## DEVELOPMENT REVIEW COMMITTEE MEETING NOTICE AND AGENDA

Notice is hereby given that the Santaquin City Development Review Committee will hold a regular meeting on **Tuesday September 8, 2020 at 10:00 A.M. at 275 W. Main Street**

2. Heelis Farms Final Subdivision Review

# HEELIS FARM TOWNHOMES

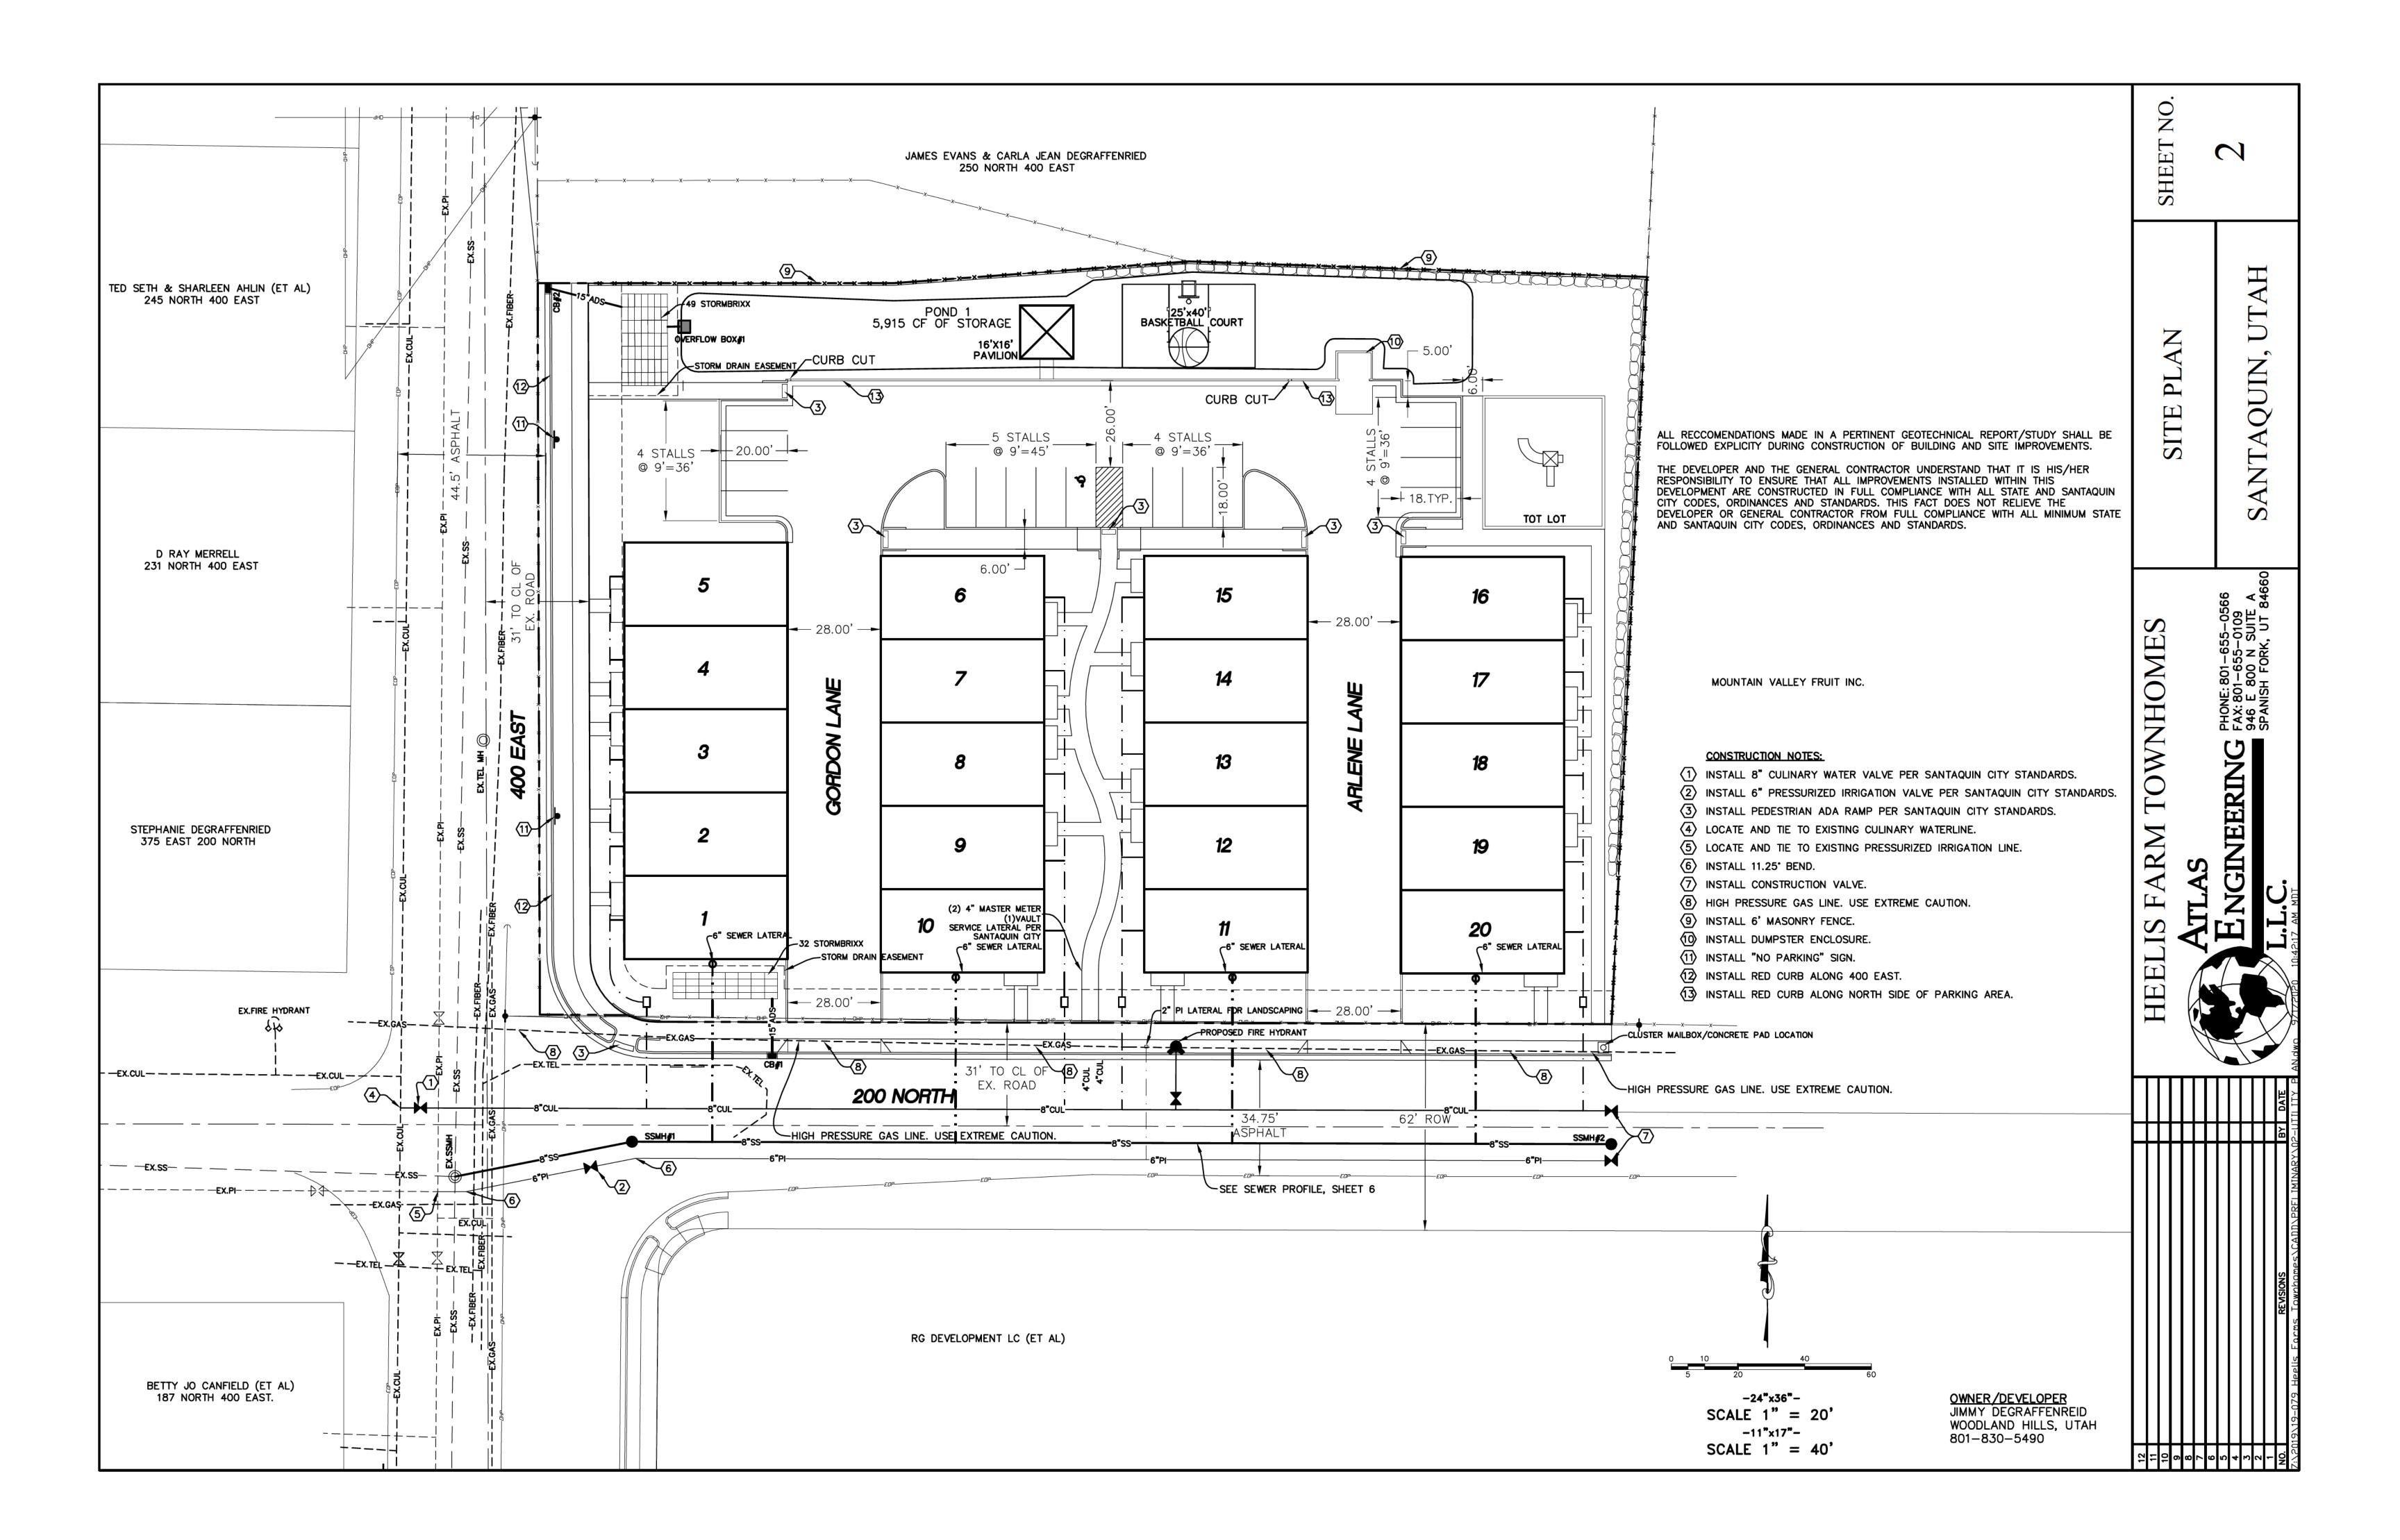
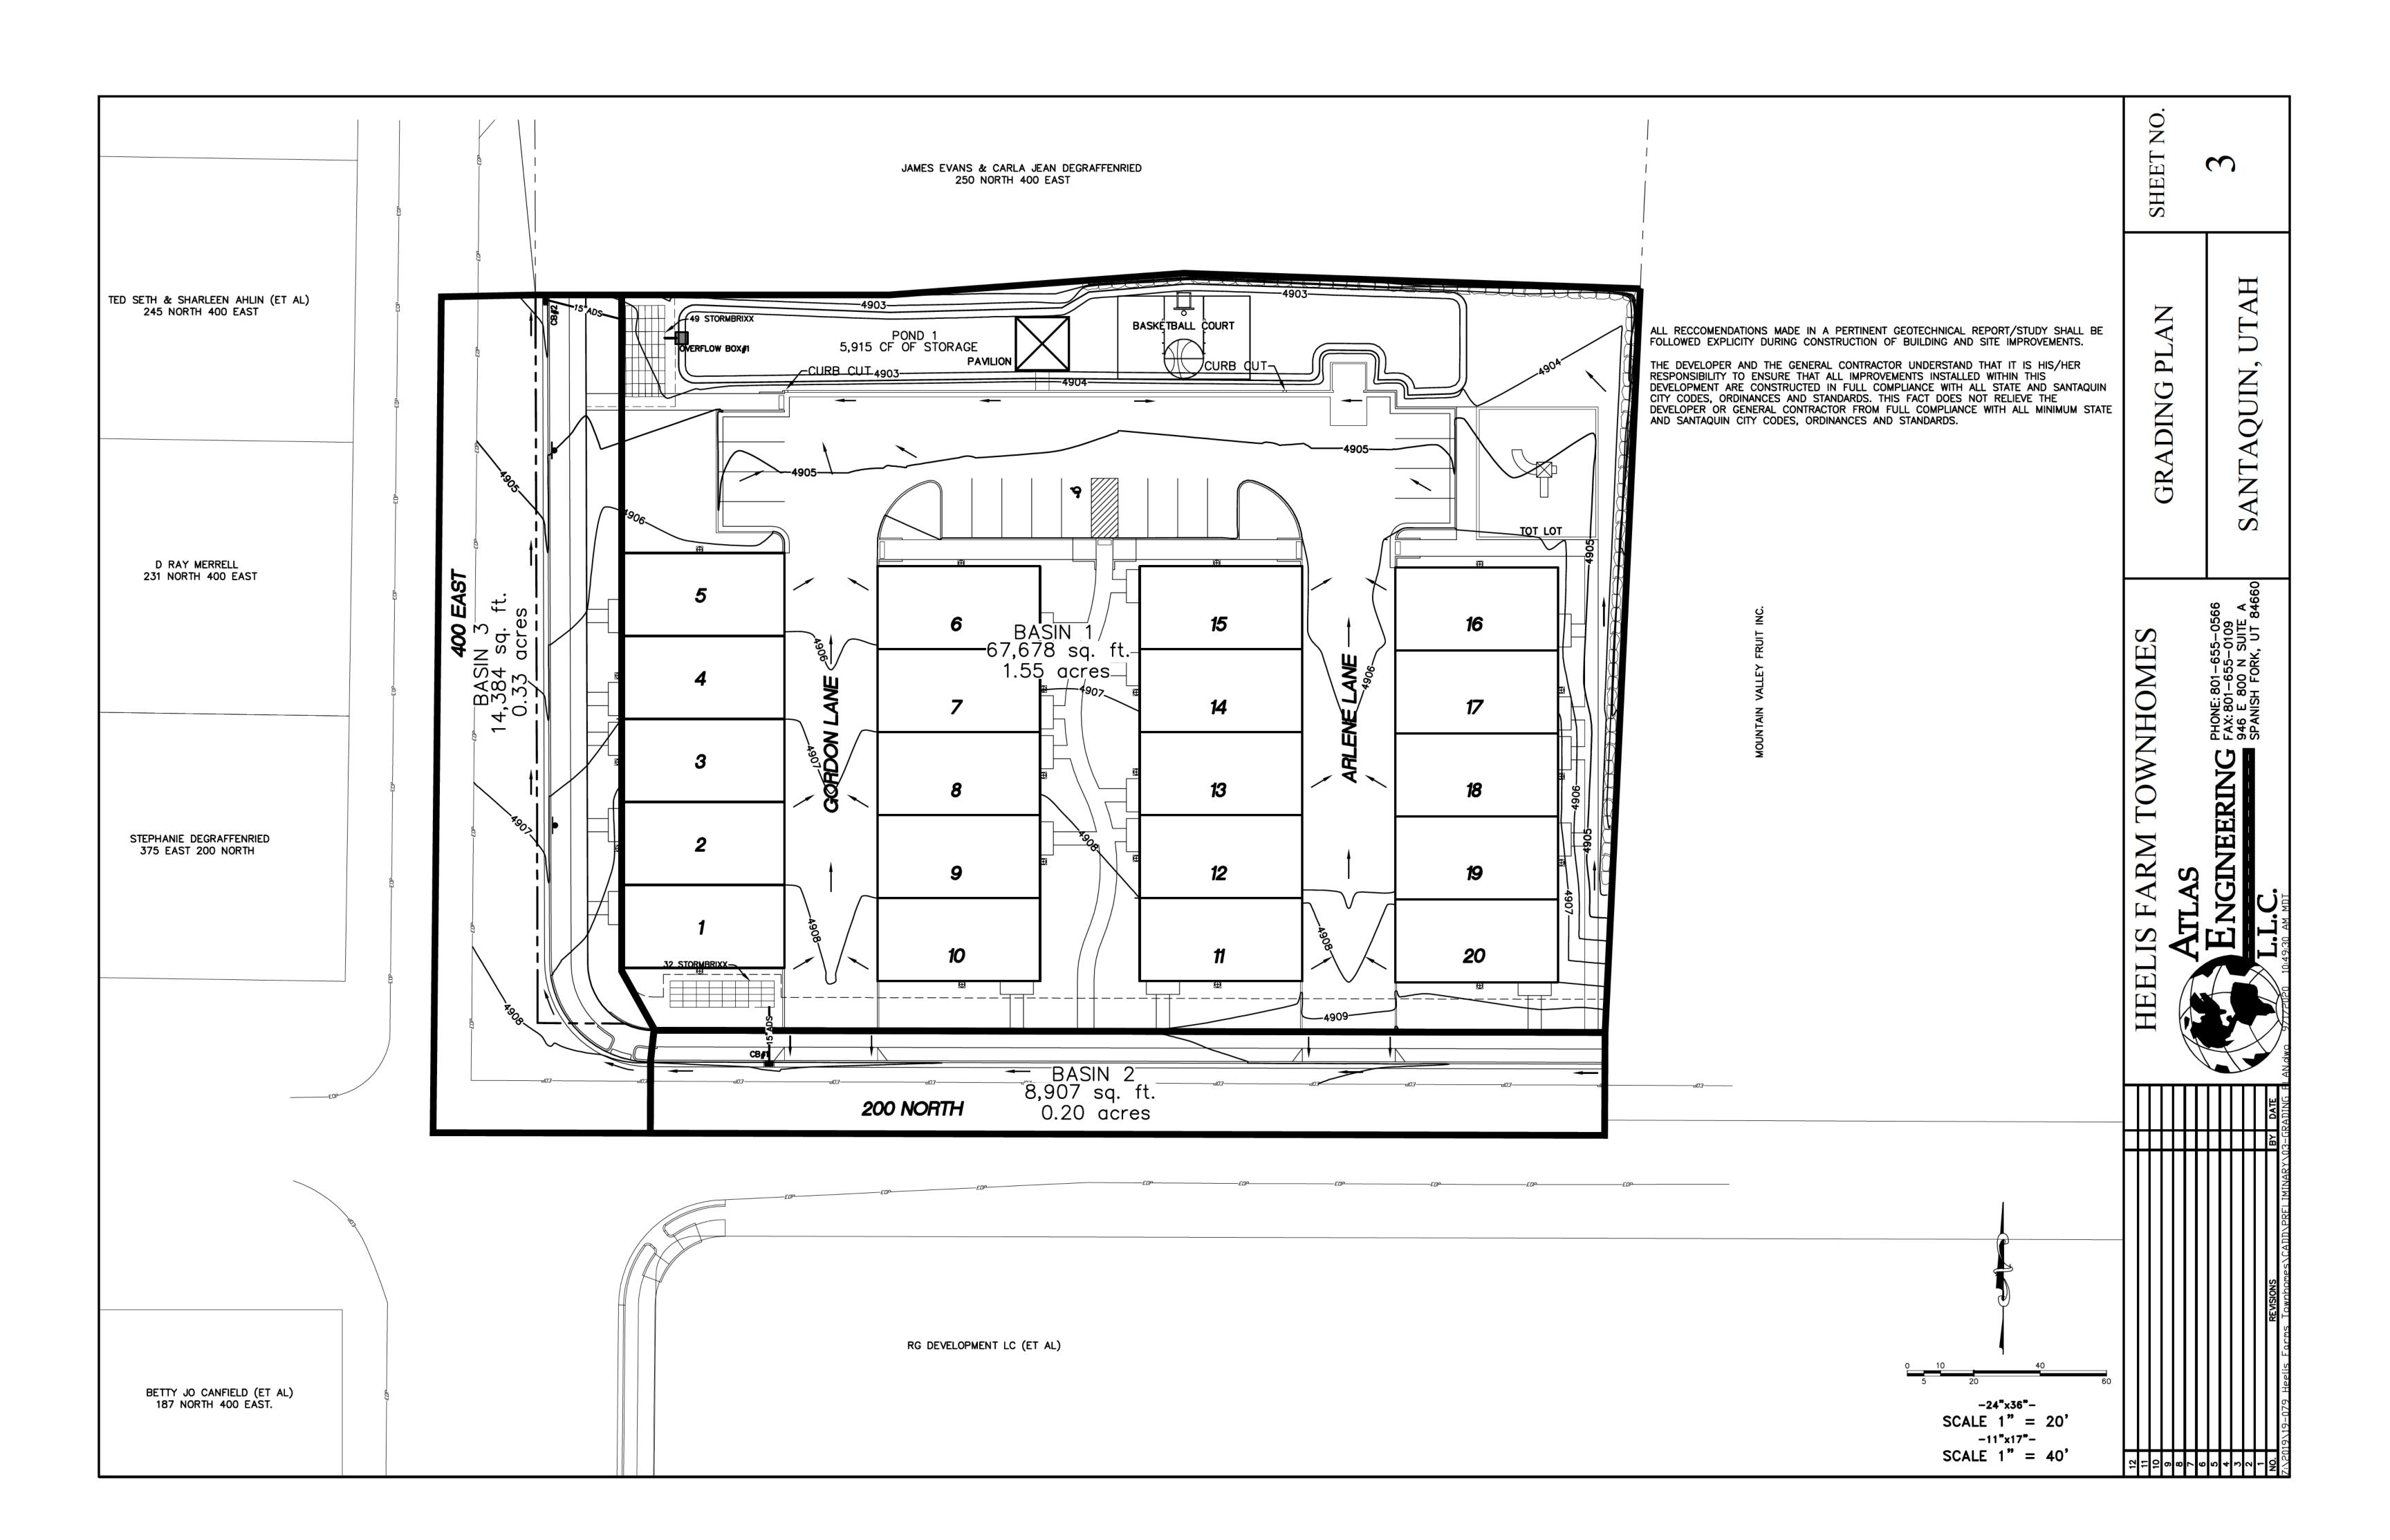
**Public Works:** Mr. Eva asked how many water meters the development will have? Mr. Lundell stated that the plans indicate that there will be two, four inch meters feeding 10 units each. Mr. Beagley explained to the developer that if both meters are proposed to be located in one vault, the vault will need to be sized appropriately for work access. Mr. Eva suggested that 4 two inch

**Police:** Chief Hurst verified that 400 East will be red curbed. He also reiterated that the trees need to be placed away from the driveway areas. Mr. Beagley explained that 400 E. will be red curbed and it will wrap around the corner of 200 N. to the first driveway of the development.

**Building Official:** Mr. Spadafora verified that the proposed addresses are off of Heelis Loop and look ok. He asked public safety to verify that the addressing works for them. Mr. Bond noted that units 10, 11 and 20 face 200 N. and suggested that they be addressed off of 200 N. instead. Mr. Reeves suggested that the roads are named East and West Heelis Loop to avoid confusion. Mr. Beagley suggested that the private access have two separate names, as there is nothing addressed off of the back of the loop. The DRC directed the developer to provide two different street names.

Engineering: Mr. Lundell stated that the CC&R's are still pending. He noted that the parking requirement is being met, but the numbers on the plans don't correlate with what is shown. He also communicated that the plan and profile for the sewer line on 200 N. is missing. Mr. Lundell indicated that there is an existing high pressure gas line that runs along the north side of 200 N. The label for the gas line must be updated to show that extreme caution be used while working around the pipe line. Mr. Lundell explained that based upon the record of survey, the south property line of the project extends straight west and doesn't follow a curve. He indicated that if the area is to be dedicated to the City, it needs to be called out and shown on the plat. He asked that the names for the private accesses aren't coordinate addresses to avoid confusion with public streets.

Mr. Greenhalgh asked why the sewer can't be installed off of the North side of the property in order to avoid tearing up the new road and the high pressure gas line. Mr. Beagley stated that the Engineering redlines are based off of the plans that have been provided. Different options for the sewer line were discussed. Mr. Lundell indicated that another proposal for the sewer line can be submitted and reviewed.

**Motion:** Mr. Bond motioned to table the Heelis Farms Final Subdivision Review so the missing plan and profile can be submitted and the sewer line location can be discussed and possibly reconfigured. Mr. Spadafora seconded. The vote was unanimous in the affirmative.
